2016/01/21

MVBA-2100/MVBAT10,20 Booster Regulator Series Components Exterior Color Change Notification

A.MVBA-2100

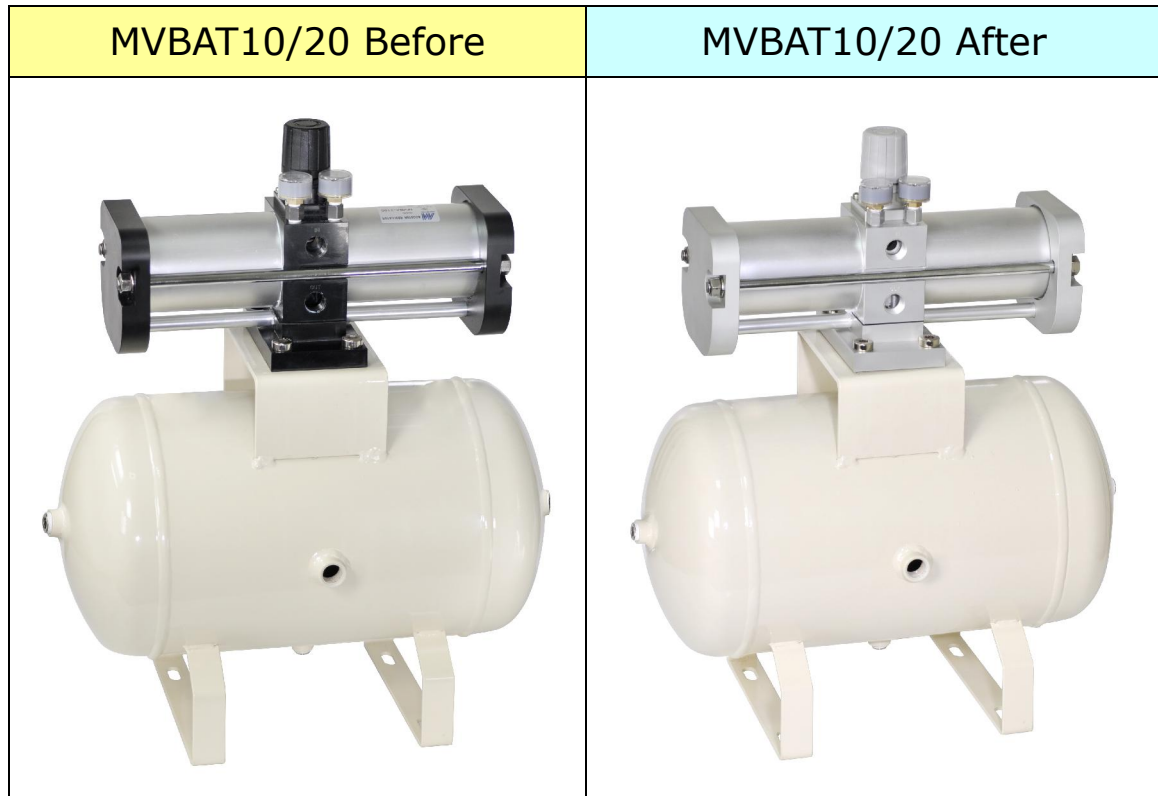
1. Product Series
MVBA-2100/MVBAT10,20 Booster Regulator Series.
2. Design Change Reason
To strengthen the company identification and unify the brand image.
3. Design Change
Booster regulator components exterior color change to silver gray.
(Product specifications, size no change)
